Chesterfield Railway Station Masterplan

Chesterfield Station HS2 Masterplan

Consultation Report & Designer's Response

Figure 5.1: Chesterfield Cycle Campaign Proposed Cycle Routes

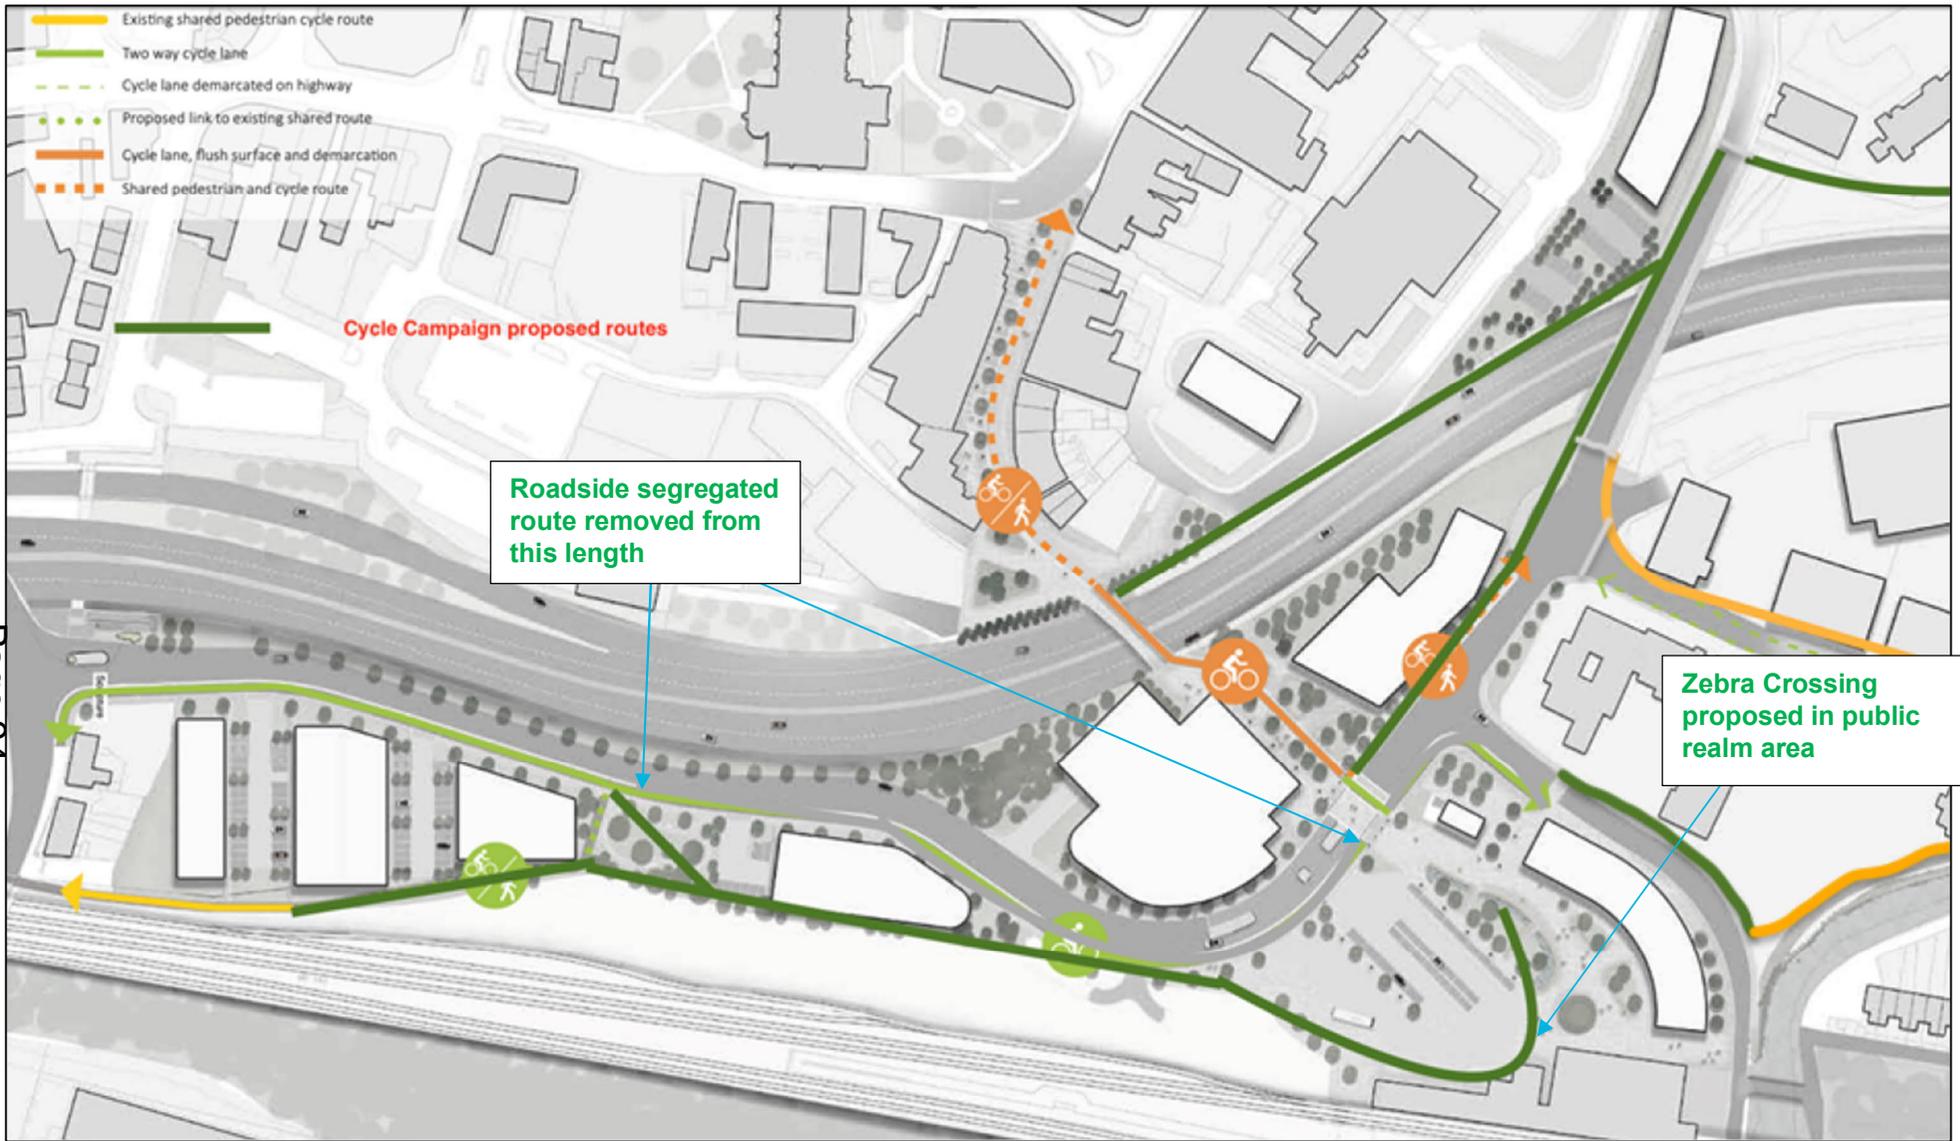
- Approaching from the south cyclists will have to cross 4 vehicle entry/exits to get to the station.
- The advisory cycle lane coming into the station from Brimington Road will disappear with no alternative provided initially.
- A shared path provided on the south side of Malkin St which should be segregated.
- This shared path ends at the Brimington Road roundabout putting cyclists back on the road in a dangerous position.
- No thought of connections towards the Trans Pennine Trail, College or Stonegravels Way."

5.15.5 Figure 5.1 shows the alternative scheme proposed by CCC.

Fig 2 Station forecourt detail

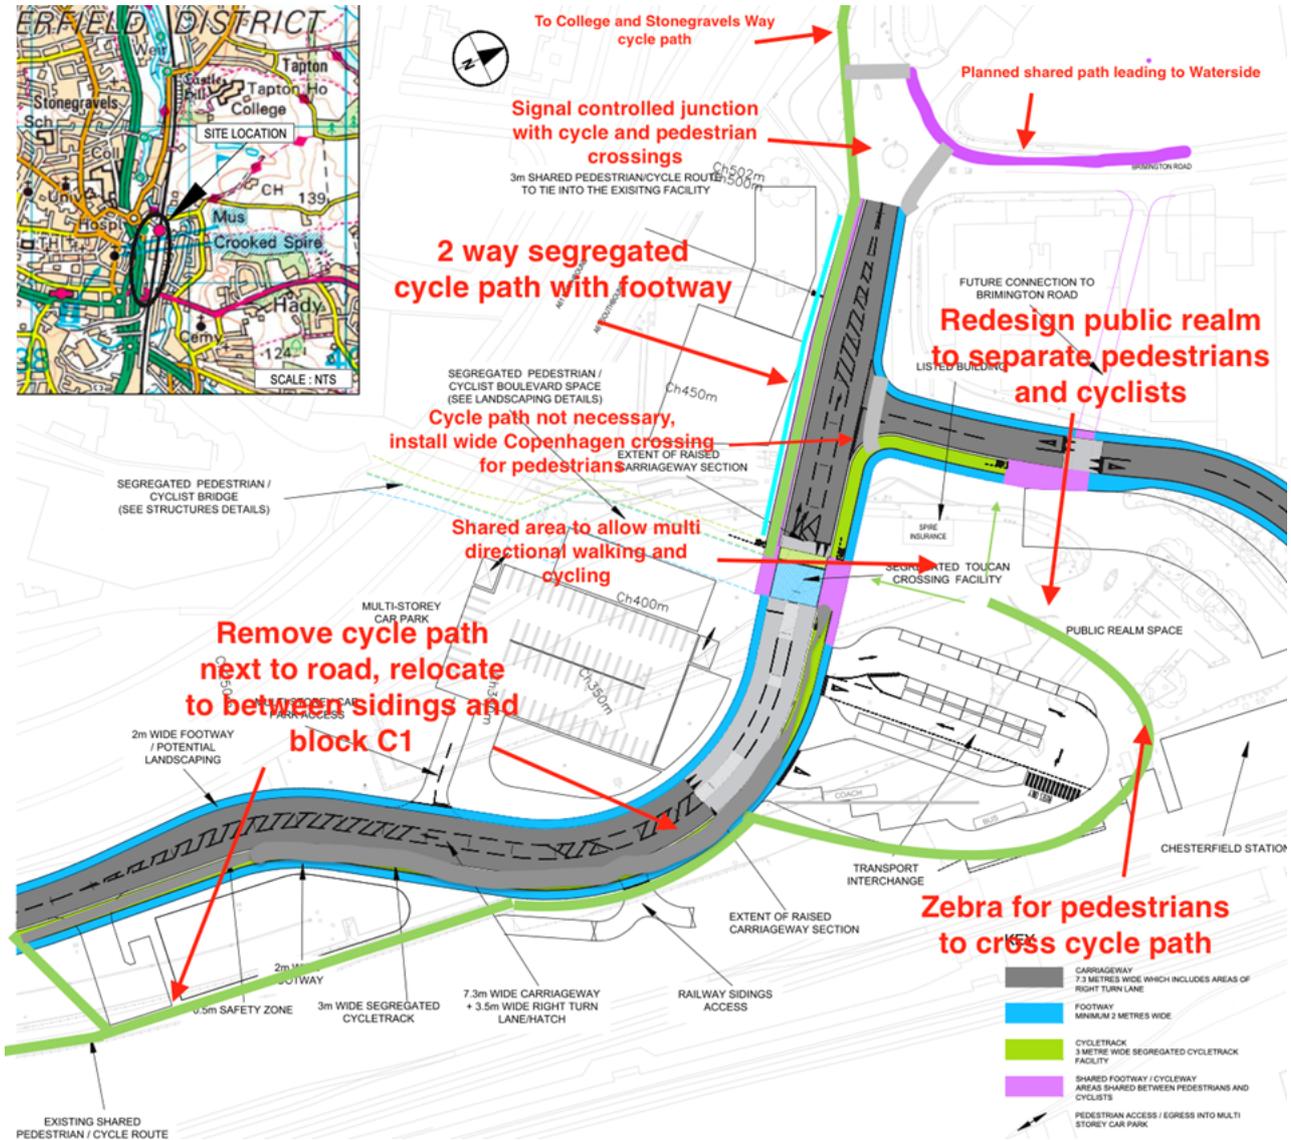
We have included two plans modified from those shown in the masterplan to illustrate the issues described above. Fig 2 shows the forecourt area in more detail with our amendments.
